Item ID: D350-567-115 Accept ***N900040100*** Setup Start ***NS1***
Revision ID: Stop ***NS2***
Item Name: Replacement Interior Window
Start Date: 5/1/2017 Start Qty: 2.00 *?
Required Date: 5/9/2017 Req'd Qty: 2.00 *?
Reference: (P.A.)SCHEDULED/S
Approvals: Process Plan: PA **DAS 21 9-89** Date: 2017/05/04 Tooling: _____ Date: _____
QC: _____ Date: _____ SPC (Y/N): _____ Date: _____
Run Start ***NR1***
Stop ***NR2***

TO AMEND INSTALLATION INSTRUCTIONS D350-567 REV. E
AND INSTRUCTIONS FOR CONTINUED AIRWORTHINESS ICA-D350-567 REV. 2
REF. TCCA STC: SH92-18
REF. FAA STC: SH989NE AND SH990NE
REF. EASA STC: EASA.IM.R.S.01560 AND EASA.IM.R.S.01561

A	NEW ISSUE (SEE PAR 16-510)	AJS	16.04.06
REV.	DESCRIPTION	BY	DATE
DESIGN	AJS	DART AEROSPACE LTD HAWKESBURY, ONTARIO, CANADA	
DRAWN	AJS	DRAWING NO. REV. A DSI 9745 SHEET 1 OF 3	
CHECKED	J	SCALE	
MFG. APPR.	N/A	NTS	
APPROVED	<i>[Signature]</i>	TITLE ALTERNATE FIRE EX LOCATION	
DE APPR.	<i>[Signature]</i>	COPYRIGHT © 2016 BY DART AEROSPACE LTD THIS DOCUMENT IS PRIVATE AND CONFIDENTIAL AND IS SUPPLIED ON THE EXPRESS CONDITION THAT IT IS NOT TO BE USED FOR ANY PURPOSE OR COPIED OR COMMUNICATED TO ANY OTHER PERSON WITHOUT WRITTEN PERMISSION FROM DA

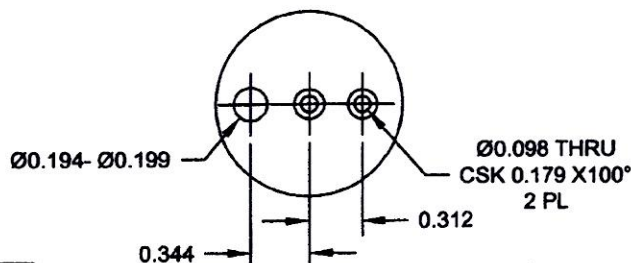
For customers with kits D350-567-013/-015/-017/-023/-025/117 @ CHG003 and later,
Customers with kits D350-567-111 @ CHG007 and later,
Customers with kits D350-567-115 @ CHG005 and later,
Customers with kits D350-567-031/-031B/-111B/-115B @ CHG002 and later,
Refer to Installation Instructions D350-567 and ICA-D350-567 and update the parts list as follows:

FIGURE 1

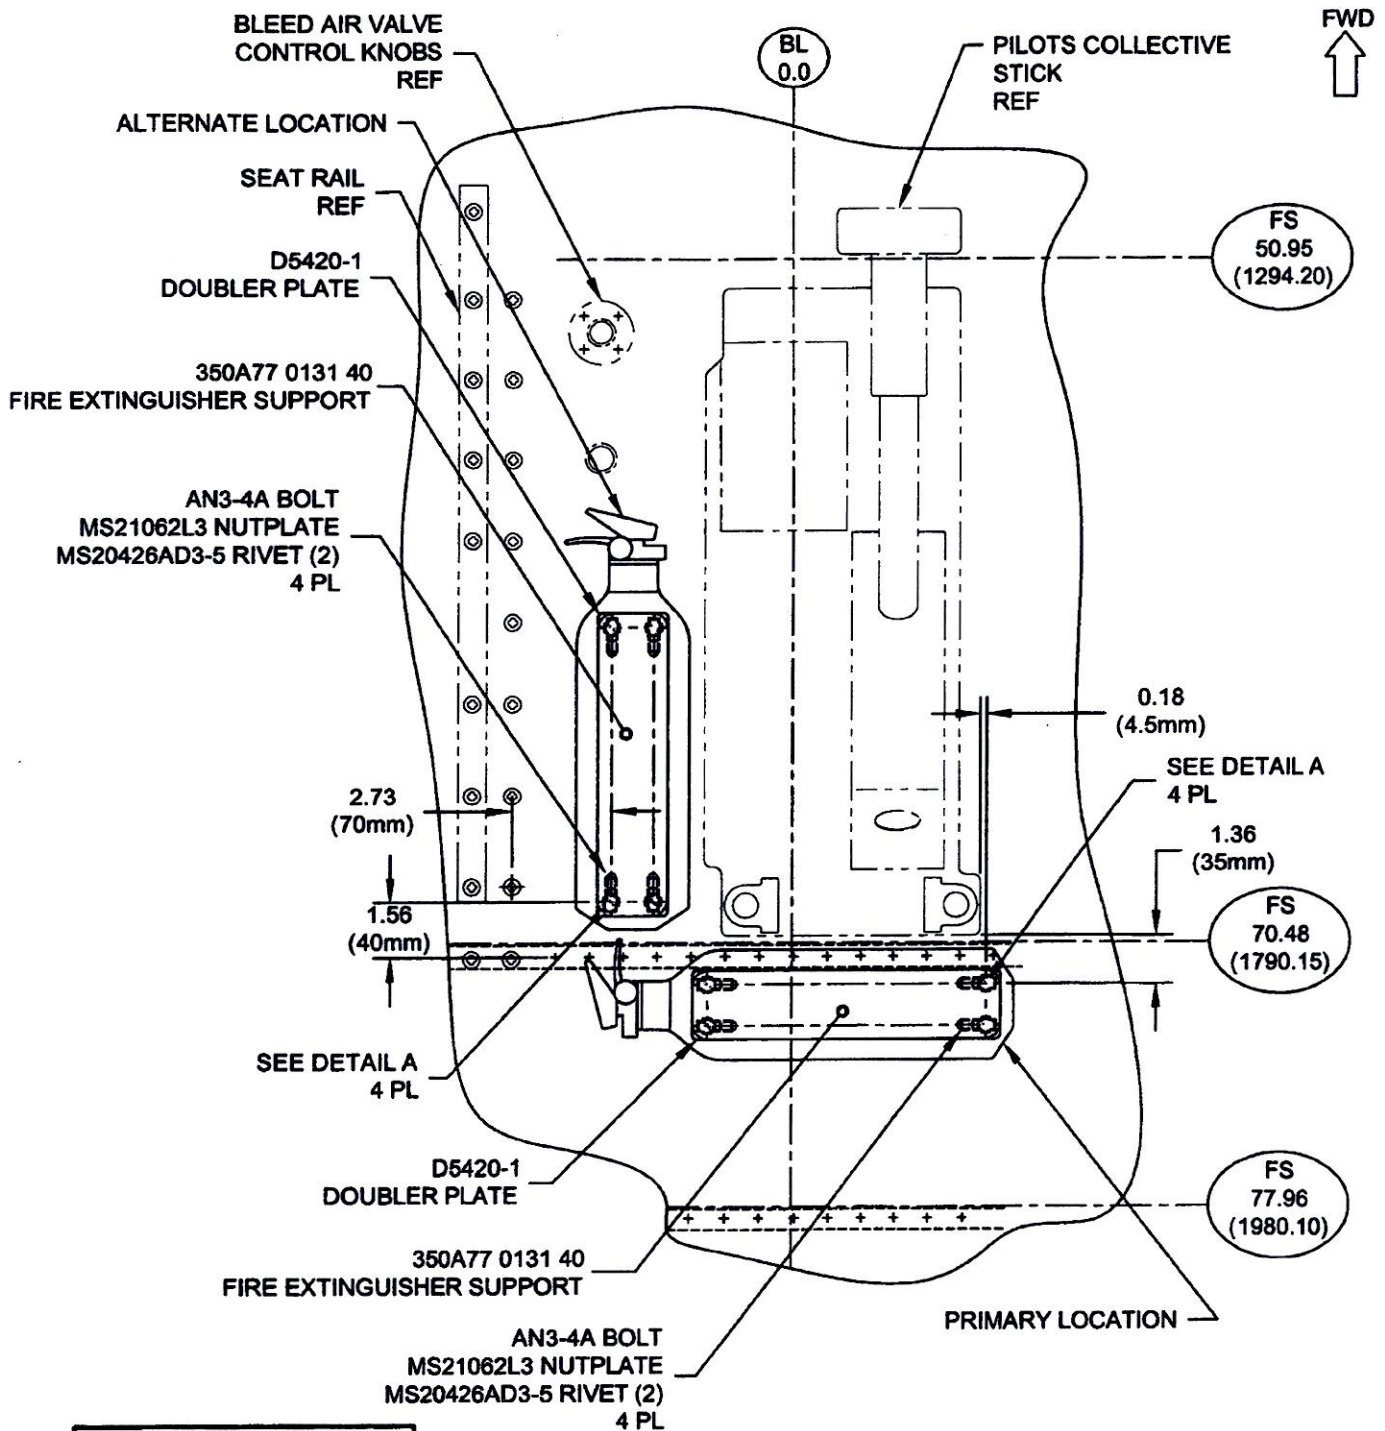
Remove and retain the cabin fire extinguisher P/N 1708337 B4 and Fire Extinguisher Support P/N 350A77 0131 40 from existing location. Per Figure 1, select the desired location for the fire extinguisher at either the "Primary" location or "Alternate" location.

Locate the D5420-1 Doubler Plate at the selected location per Figure 1 and transfer mark the holes from the D5420-1 Doubler Plate to the aircraft floor. Drill the nutplate hole pattern shown in Detail A. Touch up the drilled floor surface finish with chemical film (Alodine 1200/1201) per MIL-C-5541 and one coat of MIL-P-85582 or MIL-P-23377 primer.

Locate the D5420-1 Doubler Plate under the floor and install using qty (4) MS21062L3 nutplates and qty (8) MS20426AD3-5 Rivets (rivets fasten through floor and doubler). Locate the Fire Extinguisher Support P/N 350A77 0131 40 over the drilled holes and fasten it to the qty (4) MS21062L3 nutplates using qty (4) AN3-3A Bolts. Torque bolts 20-25 in-lbs (2.3-2.8 N-m). Reinstall the P/N 1708337 Fire Extinguisher per the Aircraft Maintenance Manual.
